**YUCCA MOUNTAIN – REQUEST FOR ADDITIONAL INFORMATION –VOLUME 2,  
CHAPTER 2.1.1.3, SET 3 (U.S. DEPARTMENT OF ENERGY’S SAFETY ANALYSIS  
REPORT SECTIONS 1.6 and 1.7) – Identification of Hazards and Initiating Events**

Response to Request for Additional Information, Volume 2, Chapter 2.1.1.3, Third Set, Number 17.

**RAI Volume 2, Chapter 2.1.1.3, Third Set, Number 17:**

Figure 1. Location of Potential Flood Water Buildup and Subsurface Facility Features in Immediate Vicinity

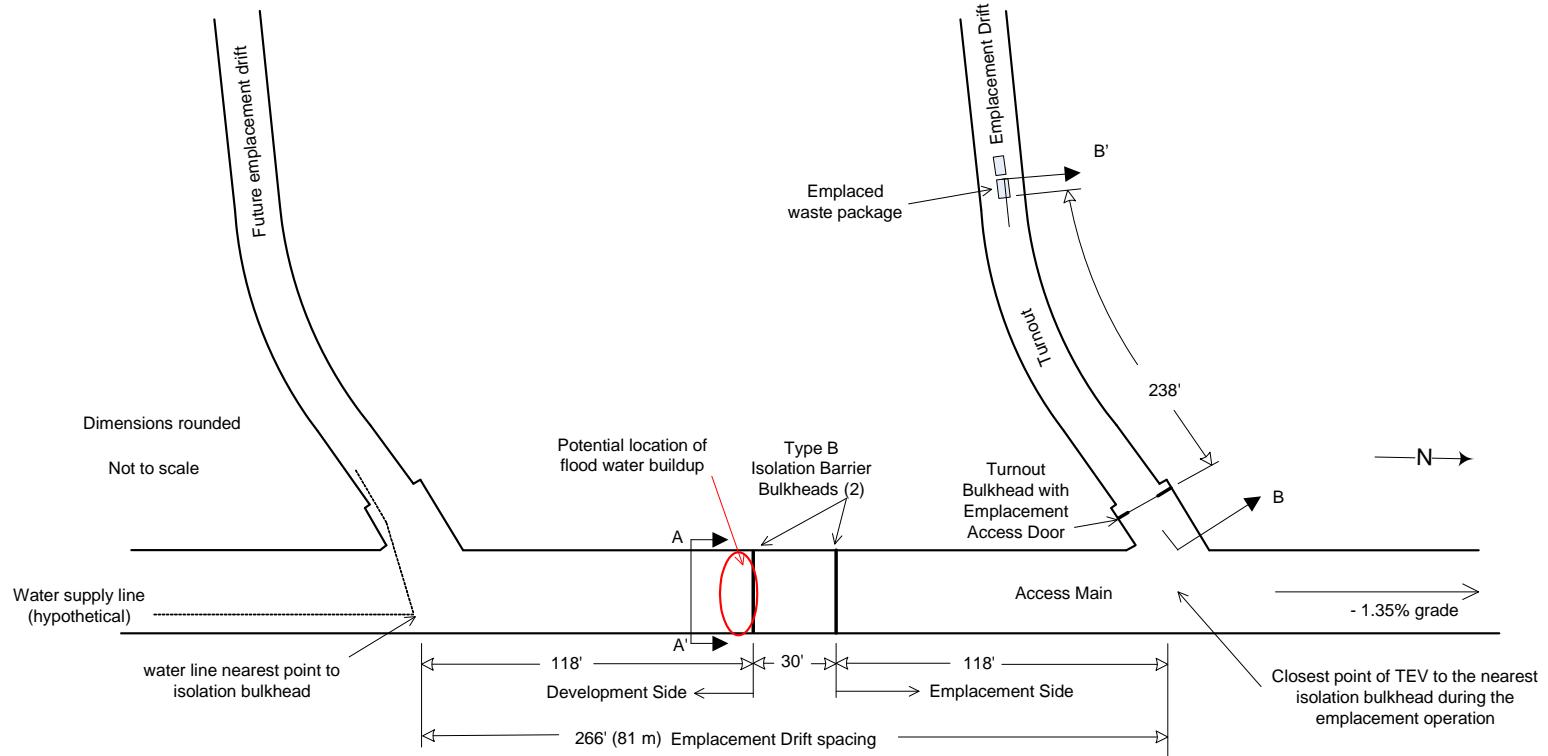
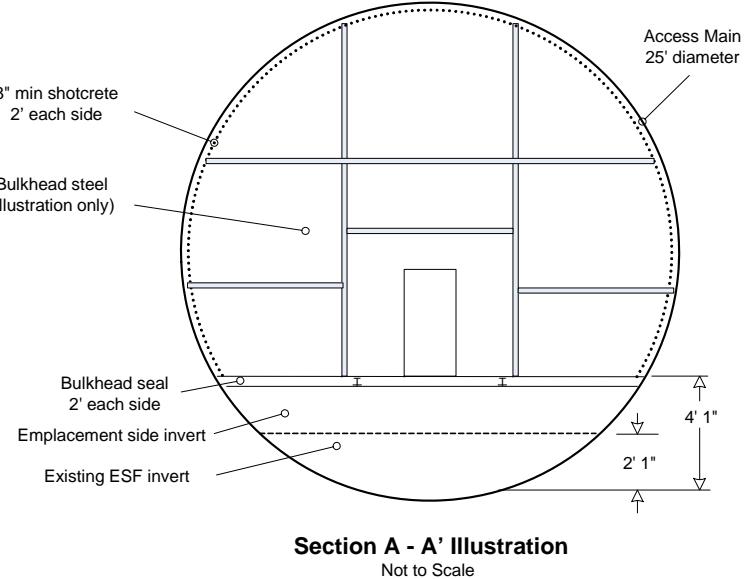
- (a) Justify why the doors of the emplacement drifts, discharge pump, construction barrier, and shotcrete seal would not be classified as items important to safety in SAR Table 1.9–1 Preclosure Safety Classification of SSCs. As part of the screening argument for internal flooding in the subsurface facilities, DOE has identified emplacement drift doors that would prevent water splash from contacting waste packages, barriers at the front of each emplacement drift, a discharge pump that would pump water out of the tunnel, a construction barrier, and shotcrete seal (BSC, 2008). In addition, on page 101 of BSC (2008), DOE indicates that, “In the event of a flood, portal security personnel can isolate flow to the tunnel (underground communications are provided during construction operations).”

- (c) Justify the conclusion that the amount of water available for internal flooding is insufficient to rise to the waste package elevation in the emplacement drifts. This is needed to assess whether failure of water supply pipes to the Tunnel Boring Machine could cause water build up high enough on the construction side of the isolation barrier. The accumulated water may flow down the access main to the emplacement side and enters the drifts with emplaced waste packages. Calculations provided in BSC, 2008, Section 6.04 seems to assume that the isolation barrier is always at the intersection of the emplacement drift and access main, which is inconsistent with the information in SAR Section 1.3.1.2.7 and SAR Figure 1.3.1–12. The calculations could have underestimated the potential maximum water levels as a result of this assumption.

Figures 1 and 2 illustrate a typical configuration of a Type B isolation barrier separating the emplacement area from the development area, distances from the barrier to the other adjacent repository openings, corresponding terminology as used in the SAR, and access main grade for the Panel 1 and Panel 2 access main. Depiction of the water supply line in Figure 1 is representational, as the SAR does not include such design information for construction activities. The Type B isolation barrier consists of two bulkheads forming an airlock compartment between the development and emplacement sides of the emplacement panel being developed. Figure 1 also shows the location of the emplacement access doors that are installed within a single bulkhead at the entrance to the turnout, as described in SAR Section 1.3.5.

Given the calculated water depths, the water would not contact the waste package being transported inside the TEV (Figure 3). This depth of water at the intersection of the access main and the turnout would not be sufficient to overcome the elevation rise to the emplacement drift level (Figure 4); therefore, the water would not enter the emplacement drift.

Figure 3. Waste Package Location in TEV during Transportation for Emplacement

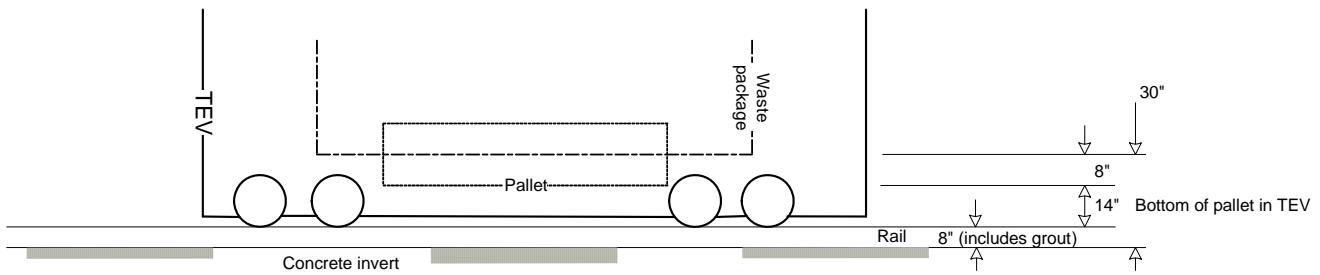
- (d) Justify why a loaded Transportation and Emplacement Vehicle (TEV) near the intersection of the access main and emplacement drift would not be affected during an internal flooding event. This is needed to assess whether an internal flooding event can affect a loaded TEV during transit in the subsurface facility.

Figure 3 represents the transport and emplacement vehicle (TEV) physical setting in the access main at its closest point of approach (approximately 118 ft) to the nearest isolation barrier bulkhead, as identified in Figure 1. This figure also provides the location of the waste package inside the TEV relative to the access main top-of-invert and top-of-rail elevations.

of the impounded water into kinetic energy once the barrier is overcome, from unsteady rapidly-varied flow to uniform “open channel” flow conditions. Hydraulic assessments for the dam break analogy are included in Attachment B, which yields an estimate of the depth of flow at the location of the TEV initiated by a sudden collapse of the bulkheads. The bulkhead thickness is very small compared to the width of a dam, so the critical depth would occur in the immediate vicinity (i.e., within a few feet) of the failed bulkhead. The maximum flow rate after the sudden collapse of the bulkheads has been estimated as  $194.5 \text{ ft}^3/\text{sec}$  (1,455 gallons/sec), which is the critical flow rate calculated based on the critical depth of flow and the channel cross-sectional area of flow. The critical depth of flow is calculated as 1.56 ft (18.72 in.). The uniform depth for the same flow rate and geometry is calculated as 1.52 ft (18.24 in.). Therefore, regardless of the location of the transition from critical flow to uniform flow, the water depth at the TEV location would likely not exceed 1.56 ft and would most likely be the uniform flow depth of 1.52 ft. The assessments indicate that, for the hydraulic conditions analyzed, the depth of critical flow and the depth of uniform flow are almost the same downstream from the failed structure. The slug of water would quickly dissipate past the TEV. For example, at one third of the maximum flow rate, or 485 gallons/sec, the total volume of 46,000 gallons of water would be exhausted in approximately 95 seconds. The maximum calculated water depth downstream from the breach of approximately 18 to 19 in. would reach the bottom of the TEV shielded compartment but would stay below the elevation of the bottom of the pallet.
